Groundwater Application Review Summary Form

Application # G- 19417

TO: Water Rights Section Date 5/10/2024
FROM: Groundwater Section Steve Ahlquist and Grayson Fish
Reviewer's Name
SUBJECT: Application G- 19417 Supersedes review of _____
Date of Review(s)

A. GENERAL INFORMATION: Applicant's Name: 1310 Gregory LLC, Brandon Taffe County: Jackson

Water-Level Measurements in Nearby Wells

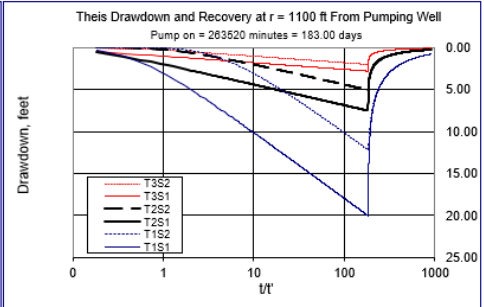
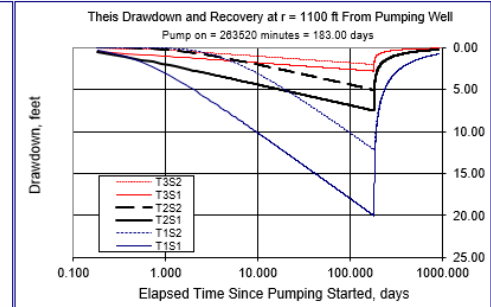
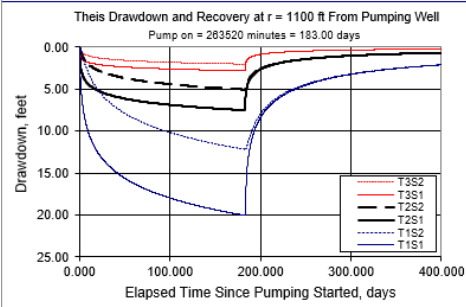
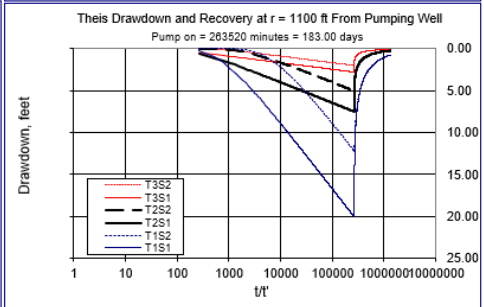
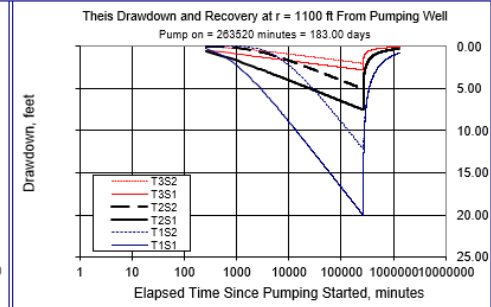
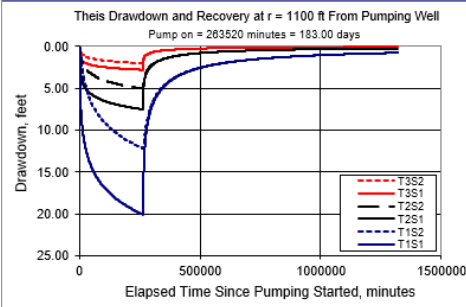
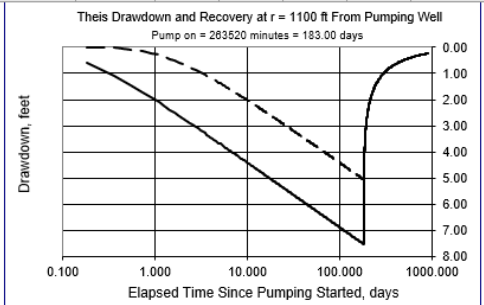
- B3. **Groundwater availability remarks:** The proposed POA (JACK 64974) is completed in the fractured bedrock aquifer of the Payne Cliffs Formation (Wiley, 1993). Water in this aquifer system is transmitted primarily through fractures and joints in the bedrock. The OWRD well report database contains records for 43 water wells near the proposed POAs (Sec. 30, T36S R1W). According to the well reports, the median and maximum yields are 20 and 400 gpm, respectively, and static water levels are predominantly shallow (median=16 feet bls; see attached Well Statistics). Water level records for nearby wells indicate that groundwater levels in the aquifer are relatively stable and do not indicate that groundwater is over appropriated (see attached Water-Level Measurements in Nearby Wells).
